SIB 12 04 23

SERVICE ACTION: REPLACE CHASSIS GROUND CABLE NUT

G01 (X3 Sports Activity Vehicle) G02 (X4 Sports Activity Coupe)

Vehicles with sDrive:

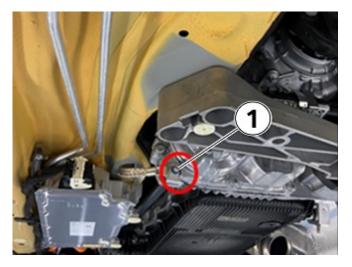
Remove the exhaust to access the transmission tunnel. Replace ground nut (1) at this location on the transmission tunnel.

Viewed looking frontwards.
